## PIC16C66 Rev. A Silicon Errata Sheet

The PIC16C66 (Rev. A) parts you have received conform functionally to the Device Data Sheet (DS30234D), except for the anomalies described below.

## Clarifications/Corrections to the Data Sheet:

**FIGURE 1: WRITES TO TIMER1 (EXTERNAL CLOCK/OSCILLATOR MODE)**

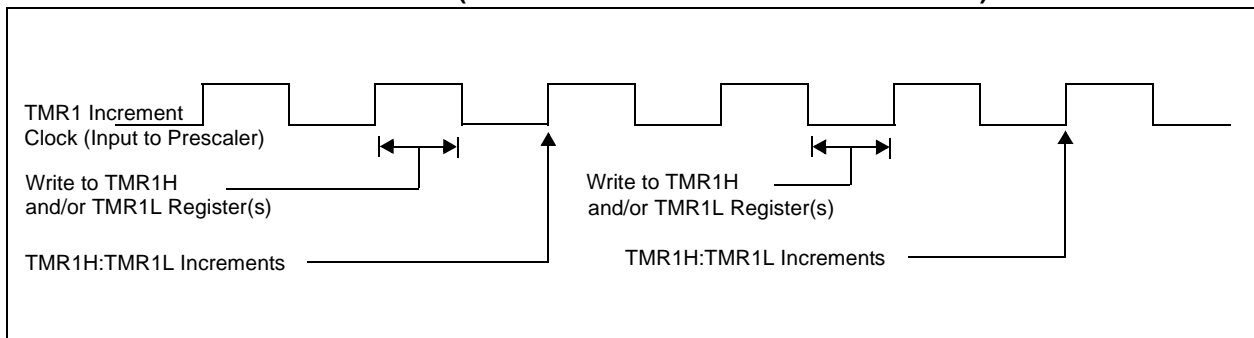
The operation of Timer1 needs some clarification when the timer registers are written and the TMR1ON bit is set.

The internal clock signal, that is the input to the TMR1 prescaler, affects the incrementing of Timer1 (TMR1H:TMR1L registers and the Timer1 prescaler). When the Timer1 registers are NOT written, the Timer1 will increment on the rising edge of the TMR1 increment clock.

When the TMR1H and/or TMR1L registers are written while this clock is high, TMR1 will increment on the next rising edge of this clock.

When the TMR1H and/or TMR1L registers are written while this clock is low, TMR1 will not increment on the next rising edge of this clock, but must first have a falling clock and the rising clock for TMR1 to increment.

Figure 1 shows the two cases of writes to the TMR1H and/or TMR1L registers. Due to the  $V_{IH}$  and  $V_{IL}$  thresholds on the oscillator/clock pins, external Timer1 oscillator components, and external clock frequency, the Timer1 increment clock may not be of a 50% duty cycle.

The TMR1 increment clock is out of phase of the T1OSO/T1CKI pin by a small propagation delay.
